Response to Submissions

Barangaroo Public Domain (SSD 16_7944): Hickson Park, Watermans Quay, Barangaroo Avenue, Wulugul Walk, Watermans Cove and the Public Pier

Figure 2 – Proposed deep soil area

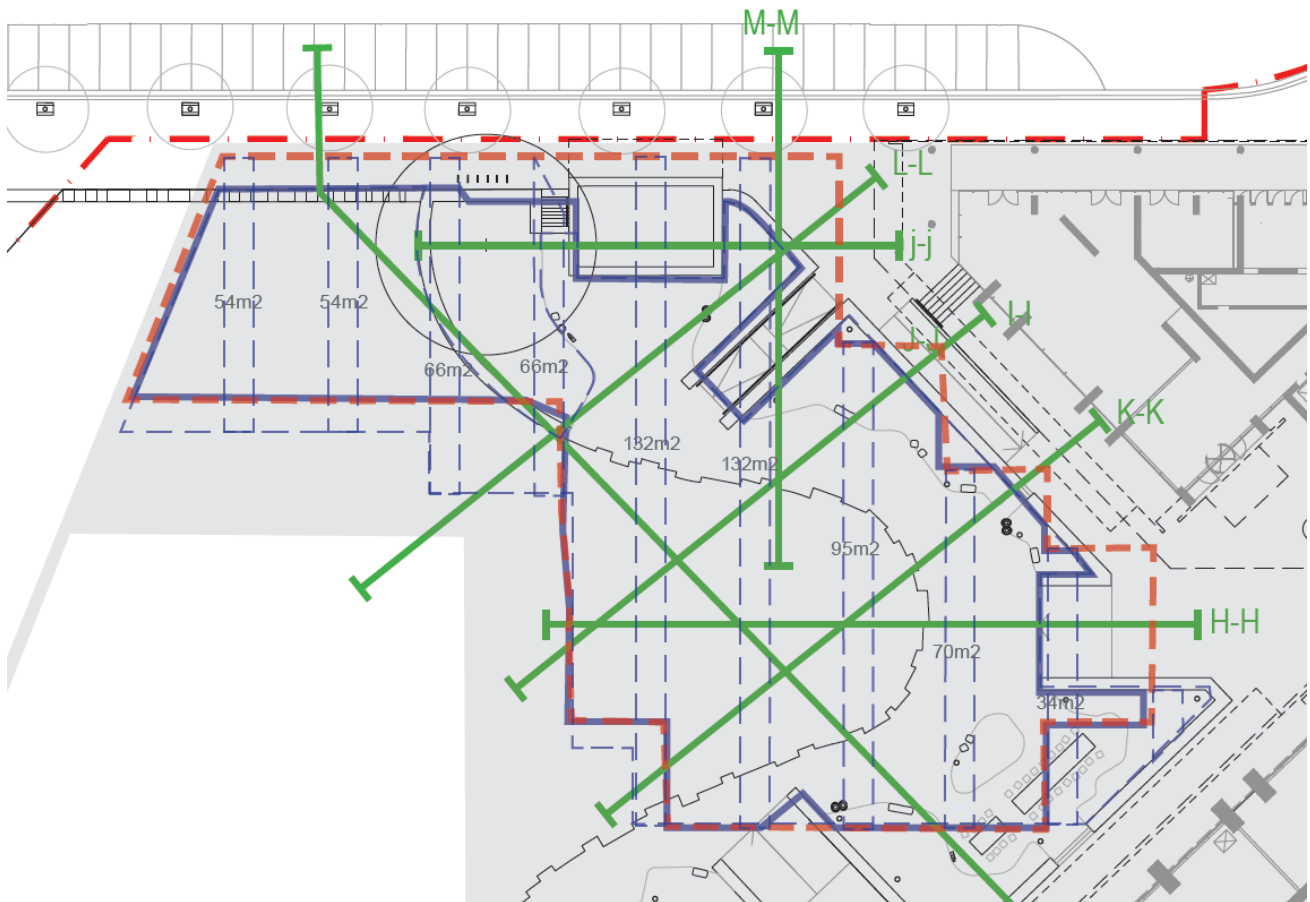
The Department has requested that the following further information be provided, relating to the proposed deep soil zones and mature trees within Hickson Park:

- Further information shall be provided regarding the final location and volume of the deep soil zone proposed in Hickson Park when considering the construction methodology for the Stage 1B basement.
- Engage an arborist to undertake a post-detailed design review of the public domain plans to confirm adequate soil depth and volume would be provided for each tree species proposed in each area (particularly large fig trees proposed in raised planter boxes).
- Provide a plan (for construction) overlaying the proposed tree planting strategy plan with the proposed deep soil zone to illustrate the correlation between large trees and the deep soil zone.

The proposed 3m deep soil zone measures 2,050m² in area and is located within a ground slab set down of 2,500m² (see **Figure 2** and **Appendix M**) and has been proposed in response to Condition B3 of the Barangaroo Concept Plan, which states:

It is clear within the drawings (**Appendix M**) that the proposed 3m deep soil zone (as shown in **Figure 2**) does not exactly match the location of trees proposed within Hickson Park. The location of the slab set down and consequent deep soil zone has been selected as a response to a number of constraints which, whilst not directly related to all of the proposed trees in the proposed park, effectively render it the only location within which the deep soil zone can be located. These constraints are defined as follows:

The slab set down proposed is the deepest which can be accommodated whilst still maintaining clearances in the basement levels below (noting that these need to be maintained for structural integrity reasons-see above). In order to maximise soil depth, the basement ground slab construction detail in the set down area requires the use of upstand beams within parts of the deep soil area. The indicative location of these upstand beams is shown in **Figure 2** (and **Appendix M**).

Specifically, in the location of these beams, the slab RL is increased from RL 0.7 to RL 1.1 (400mm), and consequently the depth is decreased by an equivalent dimension. This is not however considered significant for the following reasons:

Figure 4 – View 1, looking north-west across Hickson Park

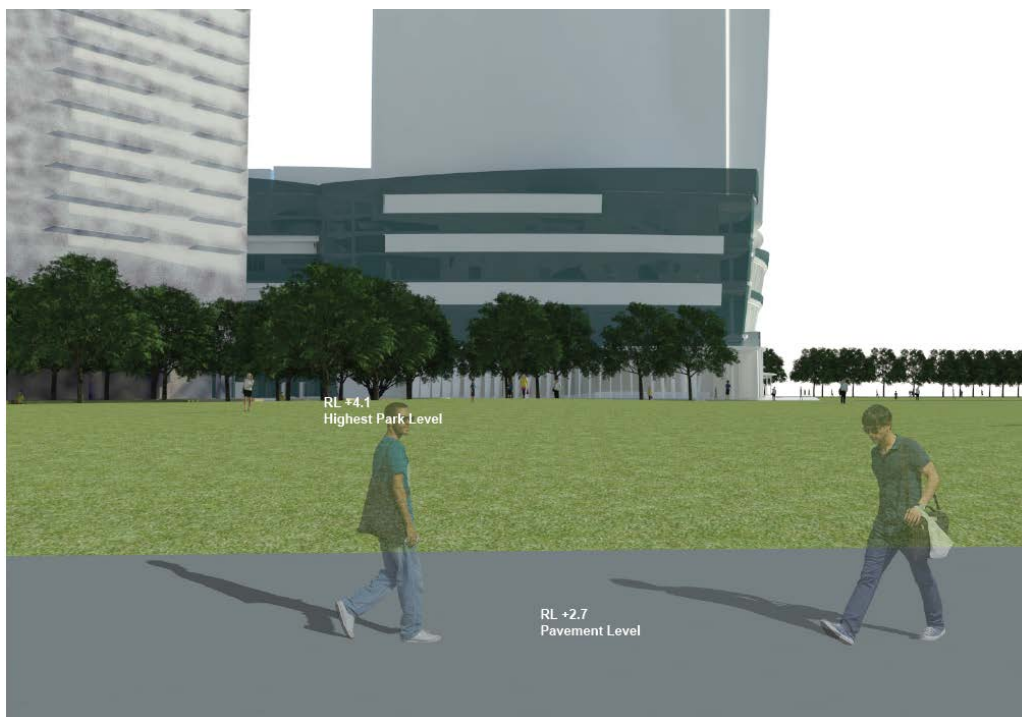
The Department has requested that further analysis and discussion of how view corridors from Hickson Road to Sydney Harbour would be provided across Hickson Park with the proposed final levels and grading.

A number of studies have been prepared to capture the view corridors from Hickson Road to the harbour, reflective of the levels proposed for Hickson Park and the public domain generally. The views which have been generated from these studies are included in the figures below (and in **Appendix N**).

Three view corridors have been selected, with view lines captured at eye height (1500mm). Two views have been selected looking from Hickson Road north-west and west towards the harbour across the easternmost portion of Hickson Park, and one view looking north-west from across Hickson Park towards the harbour from immediately south of the proposed amenities building. In each of the views, the future envelopes of the Crown Resort and the residential buildings are included, as well as the proposed landscaping scheme associated with the subject public domain proposal.

As can be seen from the figures, the public domain works, including the landscaping concept for trees along Barangaroo Avenue, and the proposed levels of Hickson Park relative to Hickson Road, provide for and maintain views from Hickson Road to the waterfront, consistent with the requirement of Condition B3(1)(b) of the Barangaroo Concept Plan.
